PLANNING AND ZONING COMMISSION

Monday, November 14, 2016

Planning & Zoning Commission
COMMUNITY DEVELOPMENT DEPARTMENT

ROUGHWOOD PUD MASTER PLAN

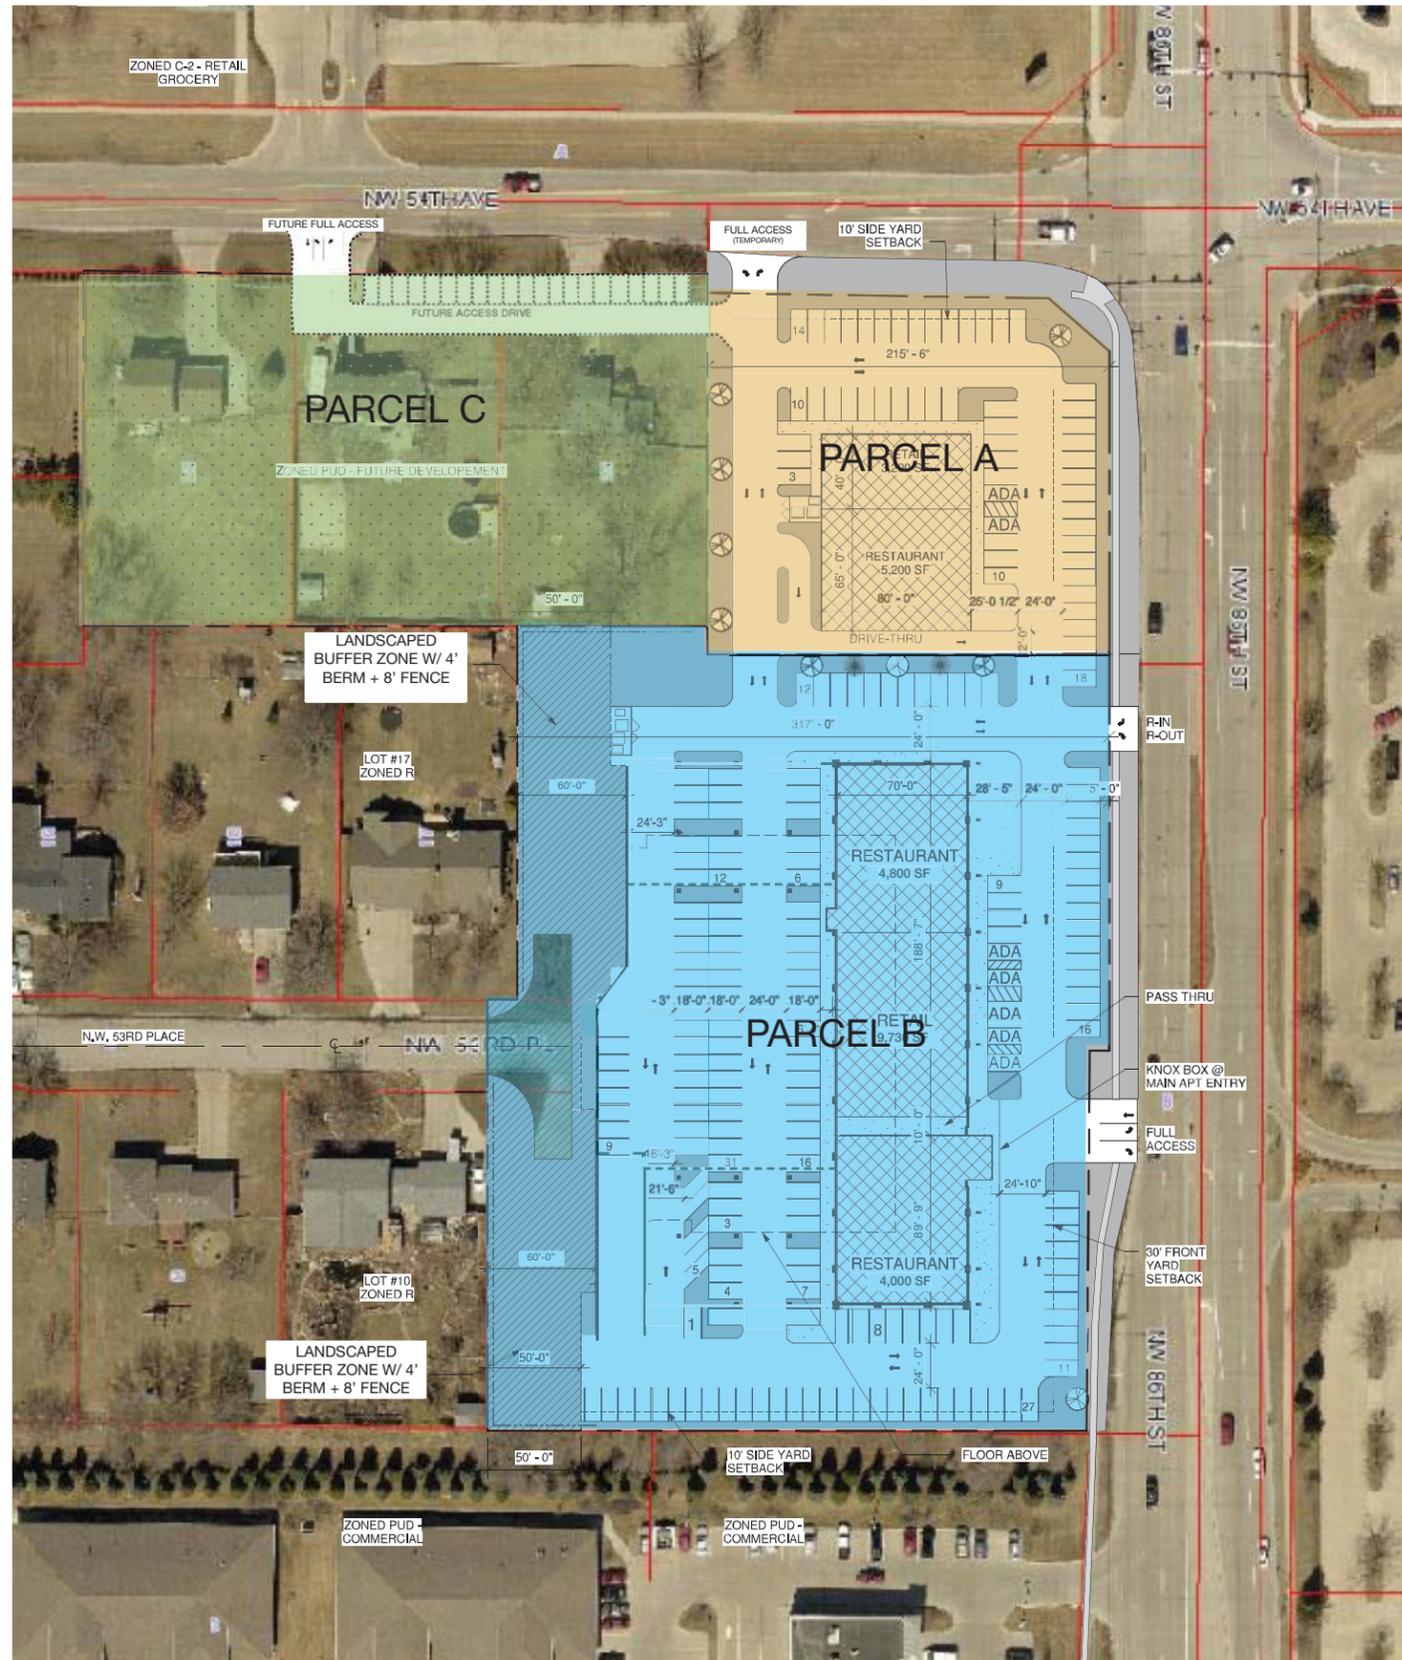
The master plan depicts three development parcels. The developer is actively pursuing development of parcels A and B. The proposed Master Plan depicts a mix of ground floor restaurant and retail use with upper-story residential totaling five-stories of development for Parcel B. The Master Plan depicts single-story retail and restaurant uses for Parcel A. Parcel C is intended as a future development stage. Allowed uses of all parcels in the PUD are described above under "Proposed Zoning".

The proposed Master Plan indicates two full-access points, one on Parcel C

The total number of spaces required across Parcels A and B is 394 spaces. As previously indicated, the development concept depicts 343 parking spaces provided between Parcels A and B for a deficit of 51 spaces. The applicant has requested Ordinance 951 address the issue by allowing a parking adjustment factor based upon the mixed use character of the development. The applicant cites a December 2015 memo developed by the Des Moines Area Metropolitan Planning Organization (MPO) which outlines best practices for parking management and design (see attached). In the memo, the MPO asserts cities should consider implementing a shared parking factor when calculating parking for mixed use developments. The concept acknowledges that mixed use developments accommodate uses that require parking at different times throughout the day. For instance, when apartment residents are at work, those parking spaces can be utilized by patrons of the retail and restaurant uses. The assertion is that requiring the maximum number of spaces for each use in total (or planning for a worst case parking scenario) leads to domination of surface parking which is

It should be noted the number of parking stalls shown on the master plan does not coincide with the number of stalls listed in the parking table on the master plan. Further, the number of required parking stalls is not tabulated correctly on the master plan. Staff has provided accurate numbers in this staff report and recommends a condition of approval to amend the master plan to rectify errors in the parking calculations and parking table.

1. The Planned Unit Development Master Plan shall be amended to indicate a right-in right-out access to Parcel A in lieu of a full access.
2. The Planned Unit Development Master Plan shall be amended to relocate the right-in right-out access from NW 86th street to meet the distance warrants found in Chapter 171.05 of the City of Johnston Code of Ordinances as well as a deceleration lane as stipulated in the traffic study conducted by Foth Infrastructure and Environment, LLC dated October 25, 2016.
3. The Master Plan shall be amended to rectify errors in the parking calculations and parking table.

Figure 2. Proposed Site Use Phase 1

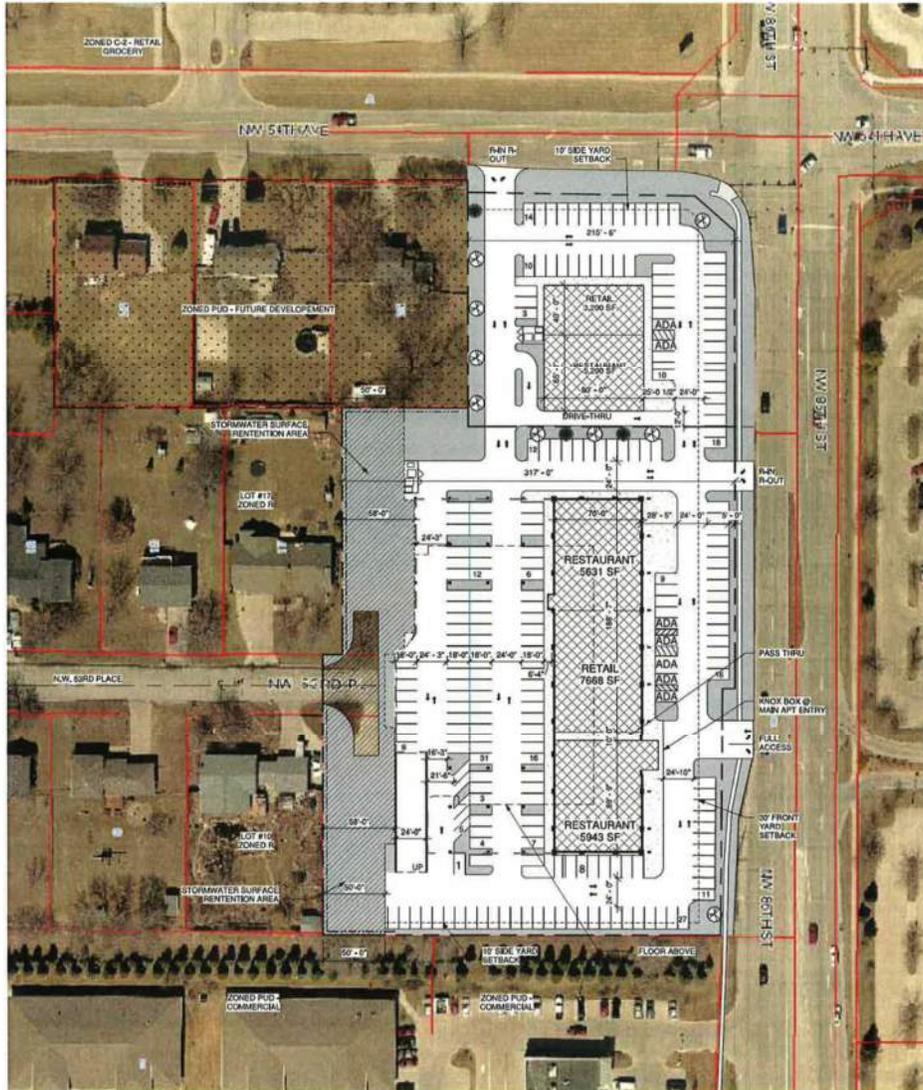
The revised Phase 1 development plan has three access points identified, one off of NW 54th Avenue and two off of NW 86th Street. The access points closest to the intersection of NW 86th Street and NW 54th Avenue are both limited right-in, right-out during Phase 1 and after the full build is completed. The second access point along NW 86th Street provides full access. A second access point, which would provide full access, along NW 54th Avenue is proposed with Phase 2 and the full build and has been included as part of the analysis. The Johnston Code of Ordinances (updated September 15, 2015) was utilized to determine the street classification and design standards for access points.

Based on the Phase 1 development plan as depicted in Figure 2, the NW 54th Avenue right-in, right-out access point is approximately 265 feet west of the intersection which exceeds the required 150 foot distance. During the initial TIS it was recommended that this access point be full access during Phase 1 and transitioned to a right-in, right-out access with Phase 2 and the full build. However, because of the slight shift in location of the access point and its proximity to the left turn taper on NW 54th Avenue, the short-term use of this location as full access is not recommended. This access location should remain solely right-in, right-out for all phases of development. The first access point south of the intersection along NW 86th Street is right-in, right-out and approximately 305 feet away which exceeds the required 150 foot distance. The second access point along NW 86th Street is approximately 230 feet south of the right-in-right-

out access point which does not meet the required 300 feet distance. This access point is directly across from NW 53rd Place.

To accommodate all four access points and meet the minimum required spacing distances, it is recommended that the right-in, right-out access point south of the 86th St/NW 54th Ave intersection is moved approximately 70 feet north, closer to the intersection. Doing so would place that access point approximately 235 feet south of the intersection which exceeds the required 150 feet distance. To reduce potential conflicts it is recommended that a short 50 foot right turn deceleration lane be added at this access point. The spacing between the two access points would then be approximately 300 feet which meets the 300 feet required distance.
